### **ADDENDUM NO. 3**

**DATE:** February 27, 2026  
**FROM:** City of Grand Junction Purchasing Division  
**TO:** All Offerors  
**RE:** Water Treatment Plant South Tank Recoating Project IFB-5836-26-DD

Project  
**WATER TREATMENT  
PLANT SOUTH TANK  
RECOATING PROJECT**

Sheet Title  
**SHELL NOZZLE  
SECTIONS AND  
DETAILS**

Sheet No.  
**S001**

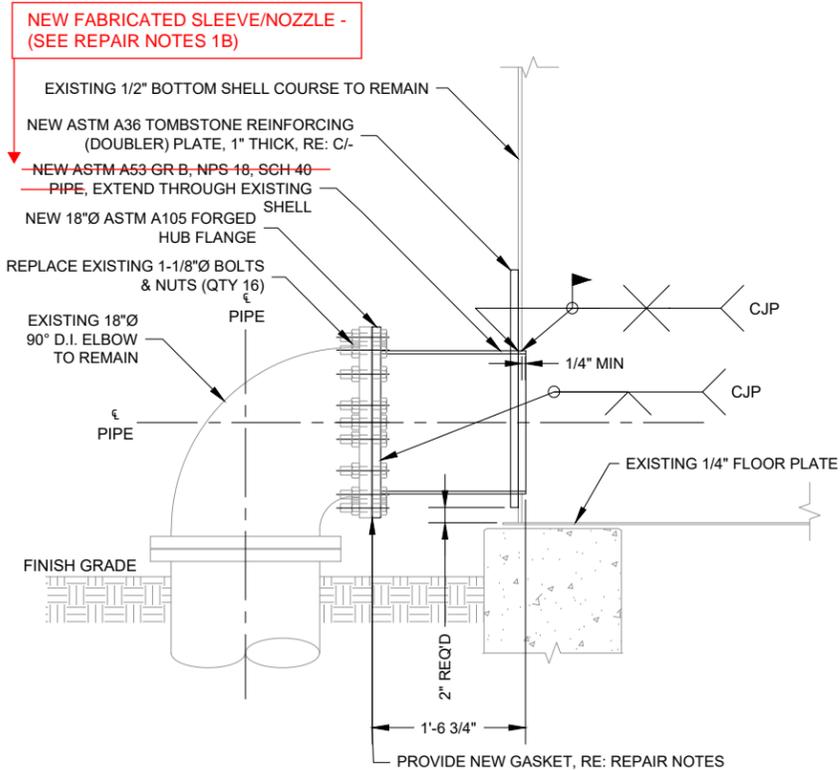
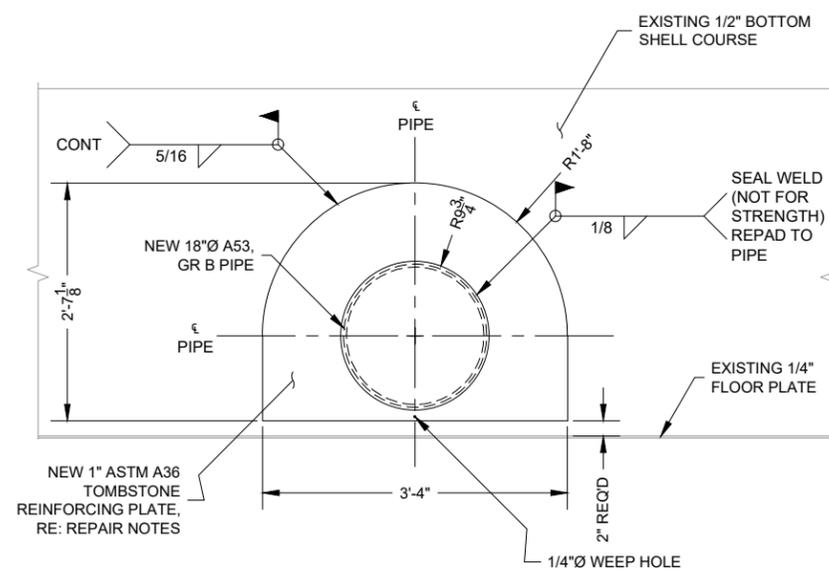
- 1. Question:** Can you elaborate on “seal exterior floor plate? Is there a drawing for this?  
**Answer:** Yes. See Addendum 1, [Engineering Design Document](#) link for Viscotaq Tank Chime Sealing System.
- 2. Clarification:** The City’s consulting engineer found a minor error in the specs/drawing. Please see attached redlined Plans containing the correction.

**REPAIR NOTES (ADDENDUM):**

- 1B. FABRICATE NEW SHELL SLEEVE/NOZZLE FROM ROLLED PLATE TO MATCH EXISTING NOZZLE OUTSIDE DIAMETER (FIELD VERIFY; APPROX. 19.1 IN.). NOZZLE WALL THICKNESS SHALL BE NOT LESS THAN EXISTING AND NOT LESS THAN 0.562 IN.

1. ~~PROVIDE NEW PIPE: ASTM A53 GR B, NPS 18, SCH 40 THROUGH EXISTING SHELL.~~
2. PROVIDE 18-INCH AWWA C207 HUB-TYPE (WELD-NECK) STEEL FLANGE. CONTRACTOR SHALL FIELD VERIFY FLANGE OUTSIDE DIAMETER, BOLT CIRCLE DIAMETER, NUMBER OF BOLT HOLES, AND BOLT HOLE DIAMETER TO MATCH EXISTING HUB-TYPE FLANGE. FLANGE SHALL HAVE MATCHING DRILLING AND A FLAT-FACE FINISH. DO NOT USE A RAISED-FACE FLANGE AGAINST A DUCTILE IRON FLAT-FACE FLANGE. PROVIDE FLAT-FACE STEEL FLANGE.
